UNITED STATES PATENT AND TRADEMARK OFFICE

APPLICATION NO.	FILING DATE	FIRST NAMED INVENTOR	ATTORNEY DOCKET NO.	CONFIRMATION NO.
10/771,654	02/03/2004	Peter W. Gavin	34814-10123	3525
2574	7590	06/12/2007		
JENNER & BLOCK, LLP ONE IBM PLAZA CHICAGO, IL 60611			EXAMINER WENDELL, MARK R	
			ART UNIT	PAPER NUMBER
			3609	
			MAIL DATE	DELIVERY MODE
			06/12/2007	PAPER

Office Action Summary	Application No.	Applicant(s)	
	10/771,654	GAVIN, PETER W.	
	Examiner	Art Unit	
	Mark R. Wendell	3609

DETAILED ACTION

Figure 6 of Campbell et al.

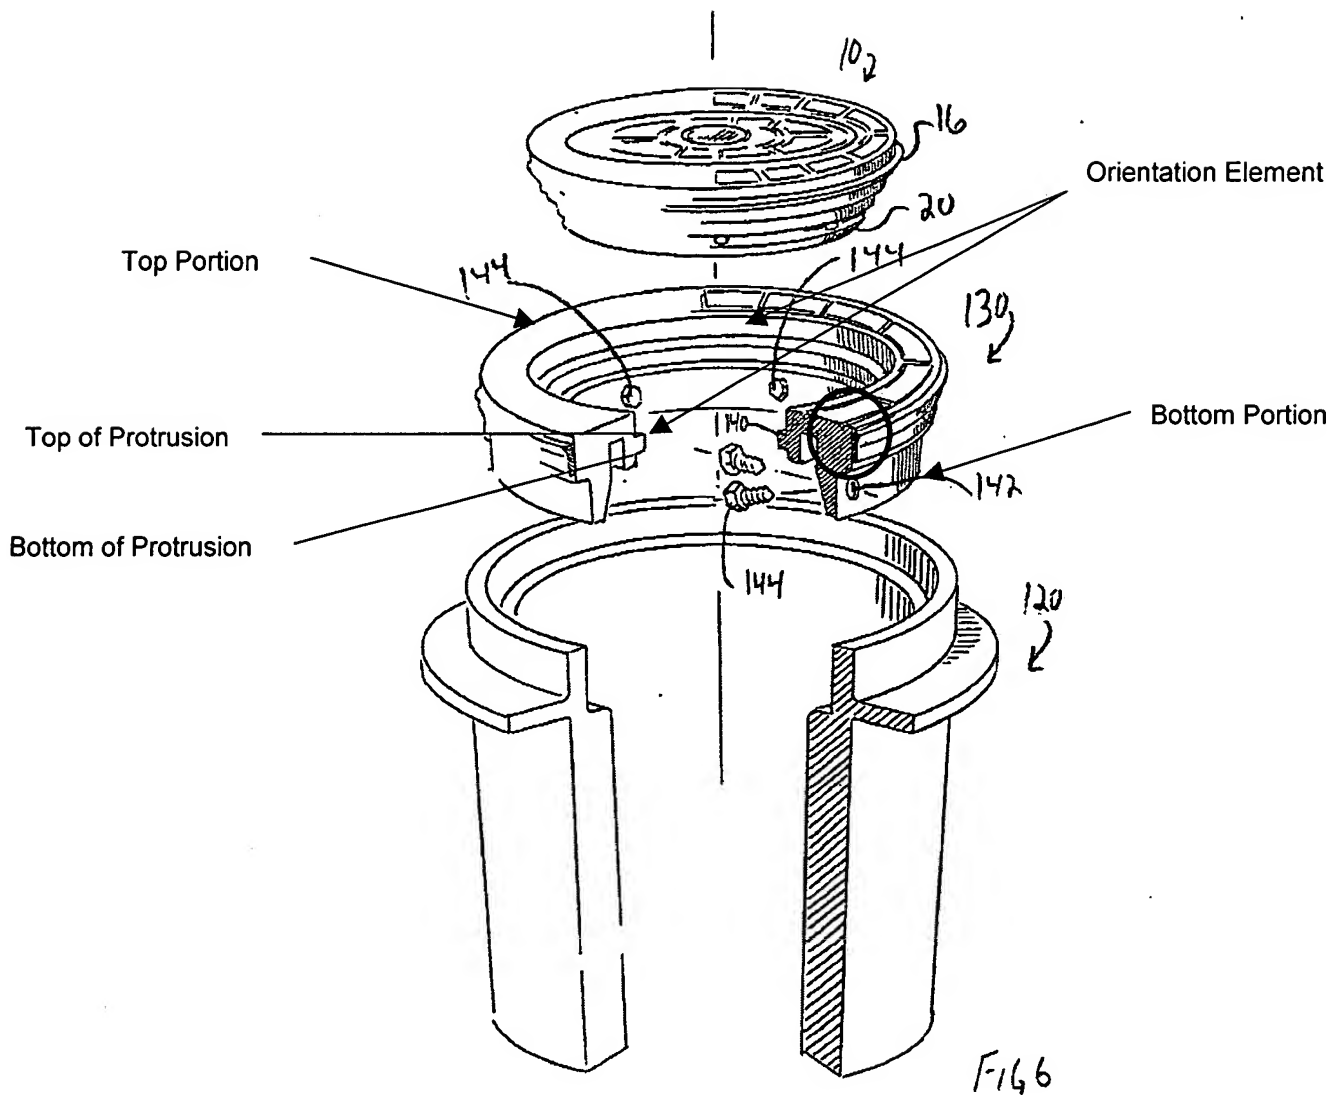
Claims 1-17, 19-25, 27-30, 32-37, 39-42 are rejected under 35 U.S.C. 102(e) as being anticipated by Campbell et al. (US Patent Application Publication Number US 2002/0166291). Campbell illustrates in Figure 6 a casting riser pan (130) comprising:

- An annular wall having a top and bottom portion (see modified figure below);
- An annular wall defining the periphery of a cover;
- An annular wall including an orientation portion forming an orientation element.

Regarding claim 3, Campbell illustrates in Figure 6 the casting riser pan (130) tapering radially outward from bottom to top. The examiner notes that the circled portion in the figure above is tapered outward further than the labeled bottom portion, thus giving rise to the casting riser pan tapering radially outward from bottom to top.

Regarding claims 4-9, Campbell illustrates in Figure 6 the casting riser pan wall having an upper and lower portion and a protruding transverse shoulder (140) extending inwardly between the two.

Regarding claims 6 and 7, the orientation element (labeled above) comprises a protrusion (140), having a top and bottom portion, extending radially inward, thus defining a recess (20) in the cover.

Regarding claim 23, Campbell illustrates in Figure 6 a casting riser pan (130) with the inner wall tapering radially outward from bottom to top.

Regarding claims 24-26, 28-31, Campbell illustrates in Figure 6 the casting riser pan wall having an upper and lower portion and a protruding transverse shoulder (140) extending inwardly between the two. Campbell also discloses the top portion of the protrusion being narrower than the bottom, where the indentation of the inner wall defines a protrusion from the cover.

Regarding claim 30, see modified Figure 6 of Campbell above. The indentation in the inner wall is labeled, which defines one of the multiple protrusions in the cover (10).

Figure 6 of Campbell

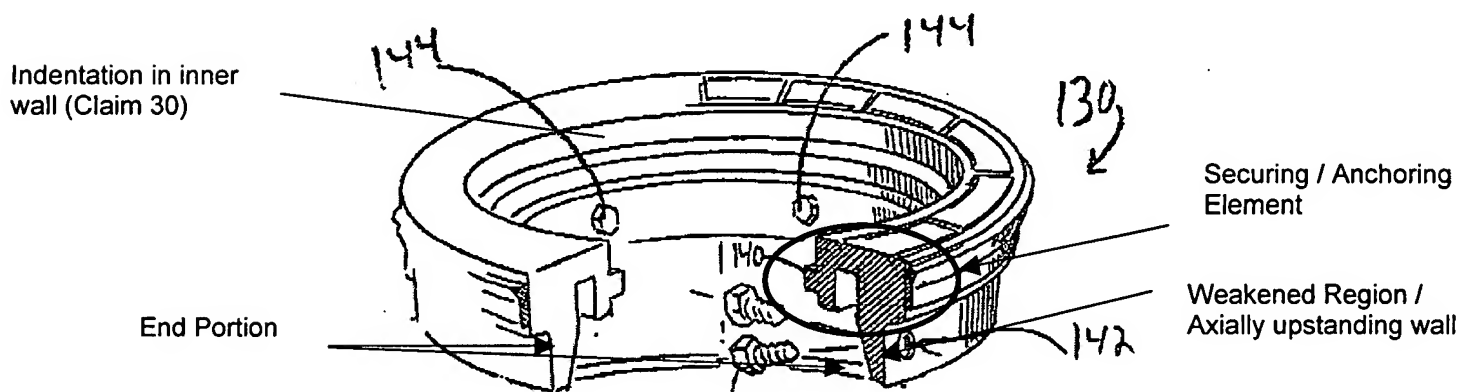
Regarding claims 10-16, Campbell illustrates in Figure 6 a casting riser pan comprising:

- A securing element extending radially inward from the bottom portion of the wall (see modified figure below);
- A weakened region connecting the securing element to the bottom portion;
- A securing element including attachment holes (142) with fasteners;
- An end portion to be received by a stackable riser (120).

- A securing element extending radially inward from the bottom portion of the wall (see modified figure above);
- A weakened region connecting the securing element to the bottom portion;
- A securing element including attachment holes (142) with fasteners;
- An end portion to be received by a stackable riser (120).

Regarding claims 36 and 37, Campbell illustrates in Figure 6 an annular anchor element (see modified figure above) extending radially outward from the outer wall.

Regarding claim 40, Campbell illustrates in Figure 6 (see modified figure above), a casting riser pan (130) with the end portion including an axially extending upstanding wall.
